ADDENDUM TO THE CONTRACT

Juneau-Douglas High School Bleacher Replacement Contract No. BE17-253

ADDENDUM NO.: ONE

DATE ADDENDUM ISSUED: May 24, 2017

1 ENLARGED RENOVATION FLOOR PLAN

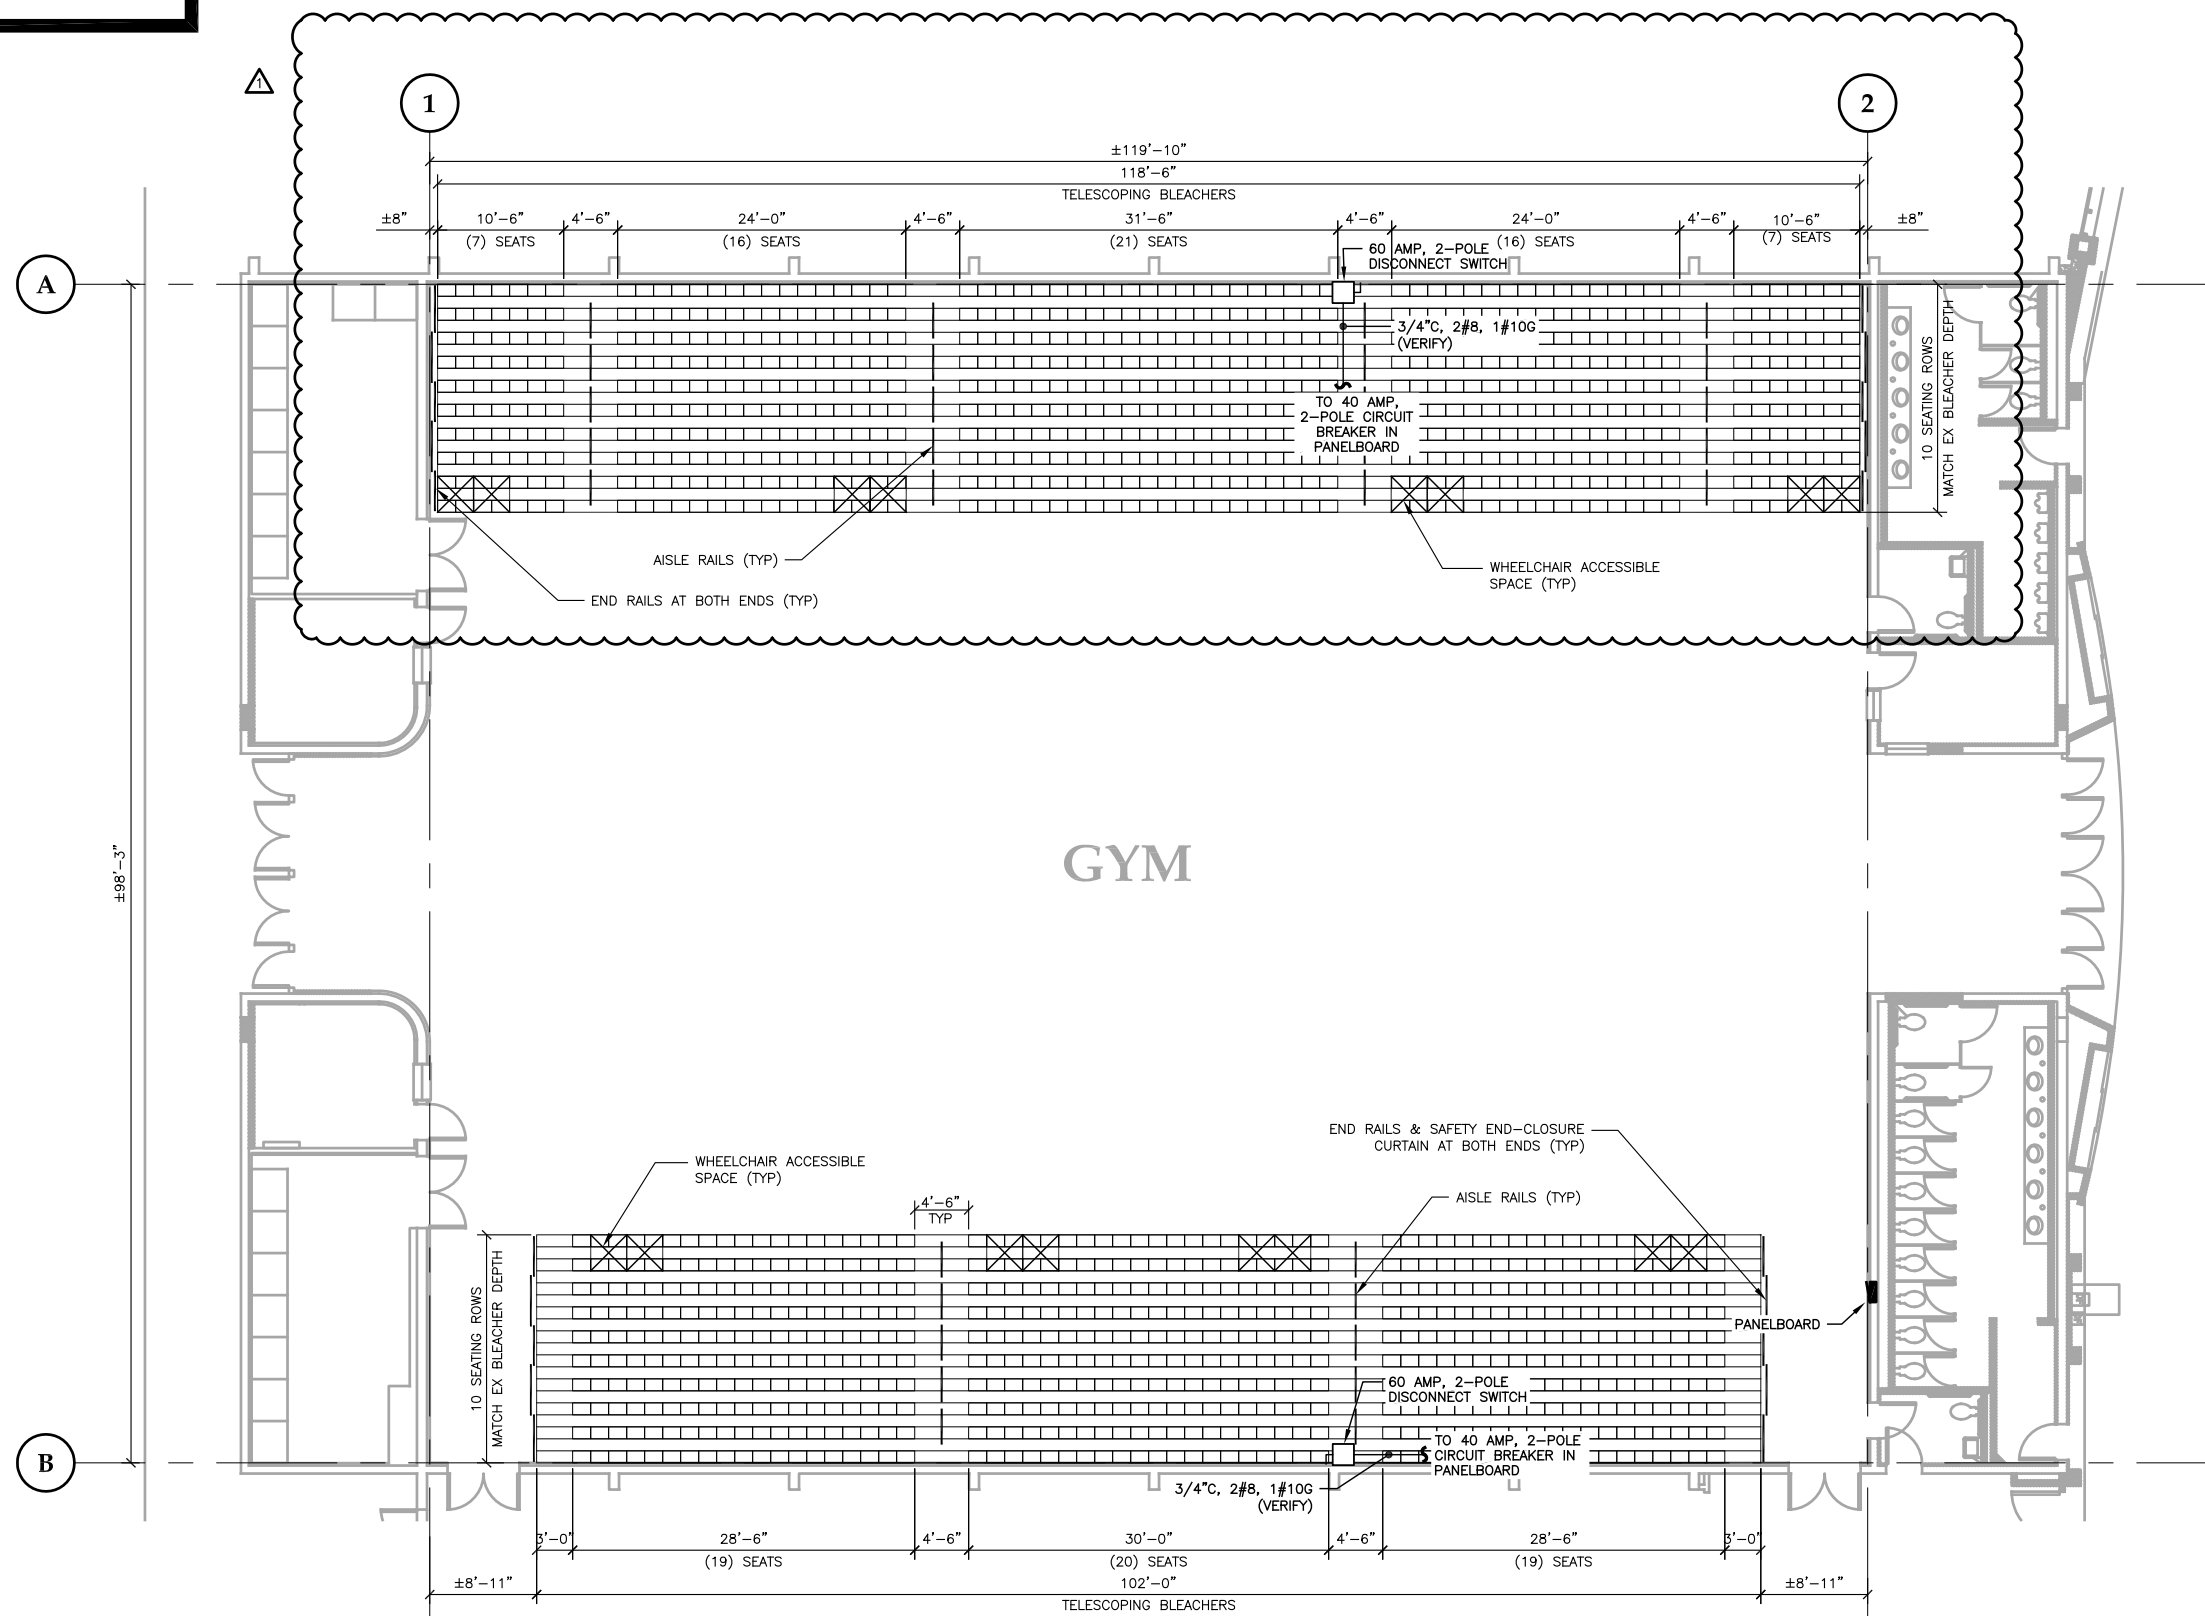
1. Question: The print shows End Rails on both sides of the gym. The North side bleachers run wall to wall. Are rails needed against a full height wall?
Answer: There is a gap of about 8" on either end so that the bleachers do not scrape against the wall as they have in the past. This will make the rails a requirement.

Item No. 3 SECTION 12660 TELESCOPING STANDS, 2.3 COMPONENTS,
Add: I. Under Bleacher Access: At bleachers without a side curtain access,
manufacturer's standard access hatch to allow under bleacher access for maintenance.
See attached A201 Enlarged Renovation Floor Plan.
